ADDENDUM REPORT

Application Number:	AWDM/1017/23	Recommendation - Delegate to Head of Planning to APPROVE subject to the receipt of amended plans
Site:	Guest House, 6 Windsor Road, Worthing	
Proposal:	Retrospective application to retain use as a 14-bedroom HMO (sui generis), and with proposed managers accommodation including new roof extensions and alterations at second floor level, single storey side extension, and retain rear garden outbuilding as managers office.	
Applicant:	Mr M Strom	Ward: Selden
Agent:	Mr Colm McKee	
Case Officer:	Rebekah Hincke

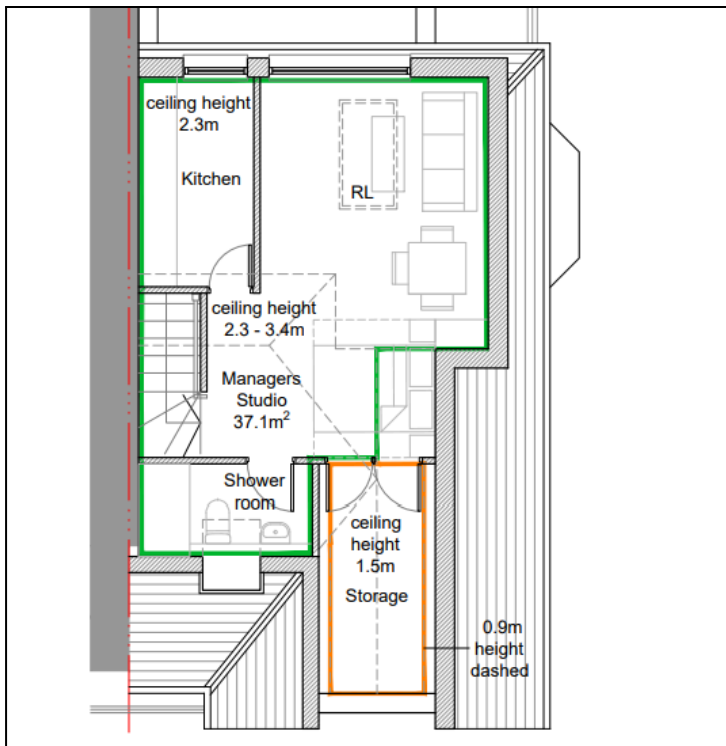
We did provide very precise calcs in line with all the criteria of the NDSS, and it resulted in a slightly larger dormer – however – this would simply result in the reintroduction of the section below, which is not at all dissimilar to the neighbour. I also note this is set well back from the frontage (the 2D image does not present a realistic view).

The latest drawings above do increase the size of the dormer and this would be larger than the dormer on the adjoining property. However, it is not significantly larger and in visual terms on balance could be considered acceptable. As the agent states his client had originally wanted a larger managers flat but amendments have been made due to the concern about the size of the proposed dormer.

Generally Officers try to resist this type of wrap around dormer and often encourage hip to gable extensions to create more room within the loft area. However, it is acknowledged that the further relaxation of permitted development rights has meant that a number of residential properties are often extended with large attractive roof extensions. There are no permitted development rights for this property but nevertheless with the extension set back from the road and the neighbouring property extended in a similar way it is considered that the latest plans can be supported from a visual point of view.

In terms of space standards this is also quite a balanced argument. There are clearly benefits with an on site presence and a Manager that can be contacted by local residents if there are any issues causing any nuisance. The difficulties of securing a good standard of accommodation within a smaller dormer is apparent and your Officers do find that the proposed accommodation is somewhat contrived (albeit as a result of trying to address the visual harm of a larger dormer). The space standards calculation does accept storage space albeit the 1 square metre referred to above is actually on the floor below and under the stairs. Nevertheless, as this is a studio within the roof, there is additional space within the eaves which is discounted and the addition of a manager's office in the garden provides additional space if required. Given that it would be difficult to resist this accommodation on the grounds of non-compliance with the space standards (as the technical measurements comply with the guidance) it is recommended that the latest plan can be supported.

In support of the latest plan the applicant has provided detailed calculations to support the latest layout (in line with the advice on National Space Standards).

GIA Calculations

Area outlined in green = 33.5sqm
This exceeds 75% of 37.1sqm.

Area outlined in orange, between 900-1500mm height = 5.2sqm
5.2sqm x 50% = 2.6sqm towards the total GIA.

Area under the stairs accounts for 1sqm towards the total GIA. Please refer to drawing 131.

Total GIA = 33.5 + 2.6 + 1 = 37.1sqm

Area below 900mm = 2.9sqm. Note this has not been added to the GIA.
